UNITED STATES PATENT AND TRADEMARK OFFICE

Office Action Summary

10/565,978

DETAILED ACTION

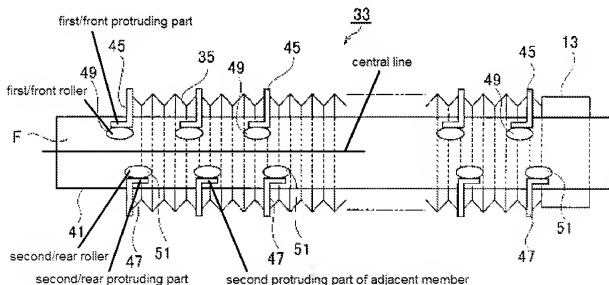
10. Consider claim 4. Sugano does not teach a guiding groove portion of the guiding tracks with a C-shaped cross section, but this is a matter of design choice. Yamanashi teaches guiding tracks (21) with a guiding groove portion with a C-shaped cross section (see fig. 4). Yamanashi teaches moving blocks (31) slidably installed on the guiding groove portion. It would have been obvious to a person having ordinary skill in the art to modify Sugano's guiding tracks with Yamanashi's C-shaped cross section in order to remove and replace one of the moving blocks in the center without removing one of the moving blocks on the end.

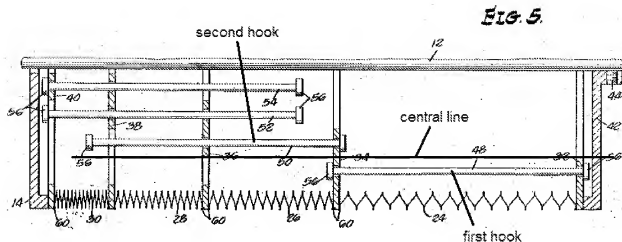
16. Consider claim 9. Sugano teaches plural moving members (29) slidable with respect to each other, but does not teach coupling members. Wentworth teaches coupling members (48, 50, 52, 54) coupled with moving blocks (32, 34, 36, 38, 40) to determine a maximum distance between the plural moving members (32, 34, 36, 38, 40; see figs. 4-5). It would have been obvious to a person having ordinary skill in the art to modify Sugano's moving members with Wentworth's coupling members in order to set a maximum distance between the moving members to prevent the bellows from bearing an excessive tensile load in the axial direction.
